STAFF REPORT

- FROM: Sonya Allen, Associate Planner 208-884-5533
- SUBJECT: H-2021-0055 Southridge Apartments Phase 3
- LOCATION: South of W. Overland Rd. and east of S. Ten Mile Rd., in the north ½ of Section 23, Township 3N., Range 1W. (Parcel #S1223120955)

Conditional Use Permit for a multi-family development consisting of 164 units on 9.07 acres of land in the R-15 zoning district.

A. Site Plan (date: 8/4/2021)

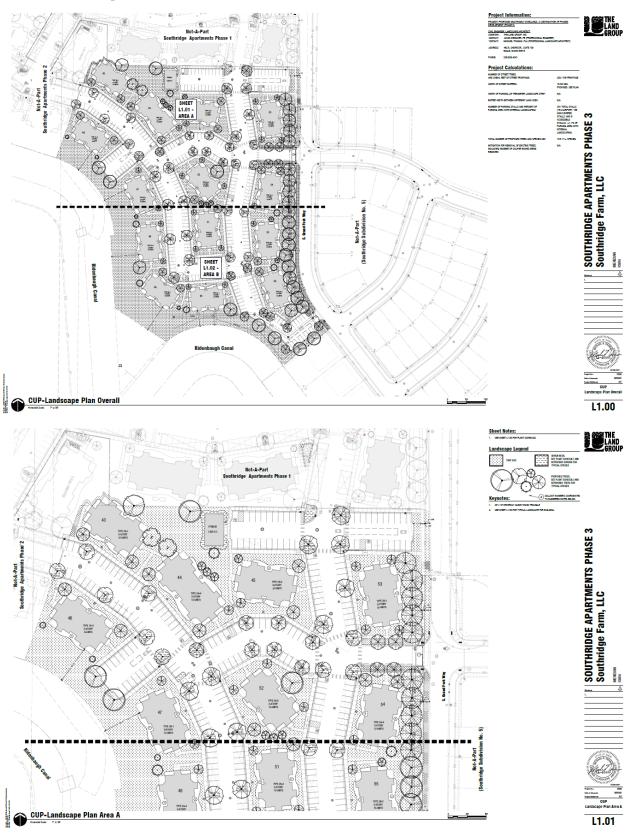
- Buildings shall provide a minimum setback of ten feet (10') unless a greater setback is otherwise required by this title and/or <u>title 10</u> of this Code. Building setbacks shall take into account windows, entrances, porches and patios, and how they impact adjacent properties. Building #43 is depicted on the site plan over the north property line; the site plan needs to be revised to comply with the minimum setback requirement or a property boundary adjustment application should be requested to adjust the boundary of the property or consolidate the subject property with the property to the north.

- 2. All on-site service areas, outdoor storage areas, waste storage, disposal facilities, and transformer and utility vaults shall be located in an area not visible from a public street, or shall be fully screened from view from a public street. *The site plan depicts screened trash enclosures; all proposed transformer/utility vaults and other service areas shall comply with this requirement.*

- 6. The parking shall meet the requirements set forth in <u>chapter 3</u>, "Regulations Applying to All Districts", of this title. *Based on 79 1-bedroom units*, 79 2-bedroom units and six (6) 3-bedroom units, a minimum of 289 off-street parking spaces are required with 164 of those being covered in a carport or garage; 165 uncovered spaces and 173 covered spaces are proposed for a total of 338 spaces, exceeding UDC standards. (Four additional uncovered spaces are proposed for Phase 2 and four carport spaces are proposed for Building 43 as noted on the site plan.)

Bicycle parking is required per the standards listed in UDC 11-3C-6G and should comply with the standards listed in UDC 11-3C-5C. One bicycle parking space is required for every 25 proposed vehicle parking spaces or portion thereof. Based on 338 spaces, a minimum of 13 spaces are required. The site plan notes each apartment building will be provided a bicycle parking area next to each entry point. **Bicycle parking in accord with UDC standards should be**

1. Easements are required over all water and sewer mains. Each utility must be covered by a minimum 20 foot wide easement, centered over the main. Easements must be free of all permanent structures including but not limited to trees, bushes, buildings, car ports, light poles, infiltration trenches, fences, trash enclosures, etc. It appears that there are areas that may have carports in conflict with easements.

- 5. The site and/or landscape plan submitted with the Certificate of Zoning Compliance shall be revised as follows:
 - a. Building #43 shall be relocated to comply with the minimum setback standard in UDC Table 11-2A-7 and 11-4-3-27; or, a property boundary adjustment application should be submitted to consolidate the subject property with the property to the north or to adjust the boundary of the property.

- b. Bicycle racks shall be depicted next to the entries of each building. At a minimum, 13 spaces shall be provided per UDC 11-3C-6G; a detail of the bicycle rack shall also be depicted that complies with the standards listed in UDC 11-3C-5C.

- c. All transformer and utility vaults and other service areas shall be located in an area not visible from a public street, or shall be fully screened from view from a public street in accord with UDC 11-4-3-27B.2.

B. Landscape Plan (dated: 8/4/21)

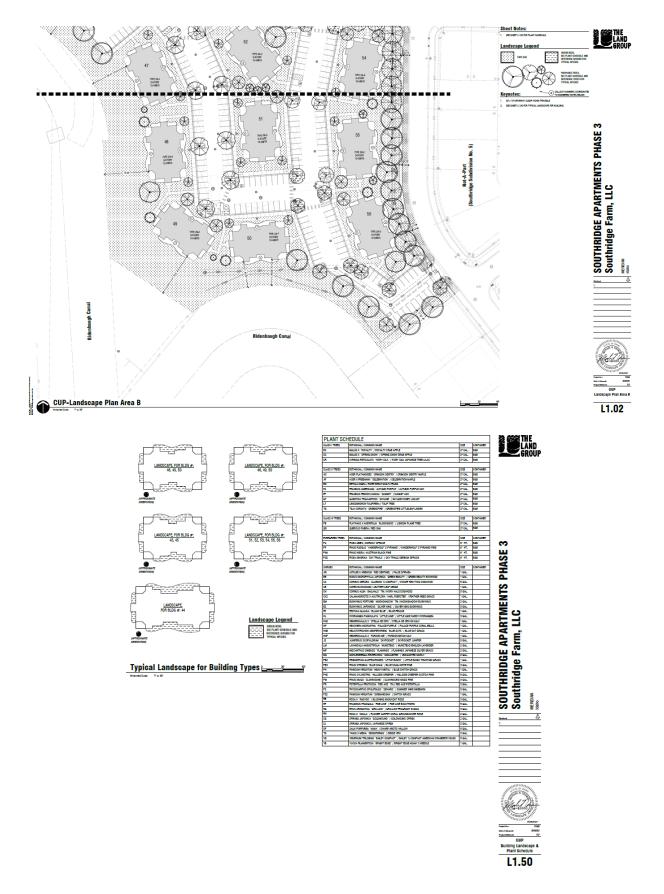
The landscape plan submitted with the Certificate of Zoning Compliance application should depict landscaping along the street facing elevations adjacent to S. Grand Fork Way in accord with these standards.

Landscaping is required within common open space areas per the standards listed in UDC 11-3G-3E. Calculations should be included in the Project Calculations table demonstrating compliance with this standard.

Fencing: No fencing is depicted on the landscape plan for this development. Any fencing constructed on the site should comply with the standards listed in UDC 11-3A-6 and 11-3A-7. To preserve public safety, Staff recommends a 6-foot tall wrought iron fence is constructed on this site adjacent to the Ridenbaugh Canal.

- d. Depict landscaping along the foundations of all street facing elevations adjacent to S. Grand Fork Way as set forth in UDC 11-4-3-27E.2.
 - e. Depict landscaping within parking lots in accord with the standards listed in UDC 11-3B-8C.

- f. Landscaping is required within common open space areas per the standards listed in UDC 11-3G-3E. Calculations should be included in the Project Calculations table demonstrating compliance with this standard.

- g. Depict 6-foot tall wrought iron fencing adjacent to the Ridenbaugh Canal to preserve public safety.
- 6. A street light plan will need to be included in the building permit and/or final plat applications. Street light plan requirements are listed in section 6-7 of the City's Design Standards. A copy of the standards can be found at <u>http://www.meridiancity.org/public_works.aspx?id=272</u>.

C. Open Space Exhibit

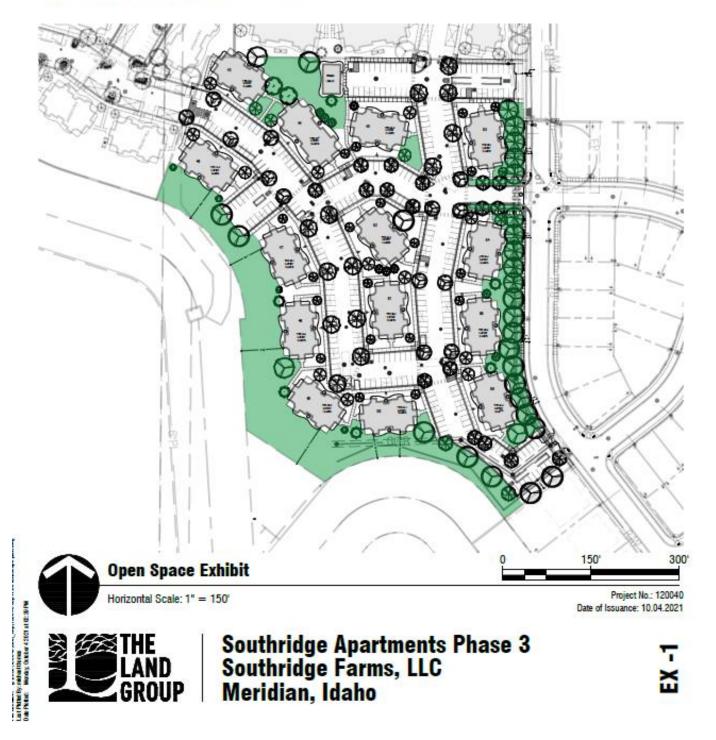
- 2. Common open space shall be not less than four hundred (400) square feet in area, and shall have a minimum length and width dimension of twenty feet (20'). *The common open space areas depicted on the open space exhibit in Section VIII.D meet this requirement.*
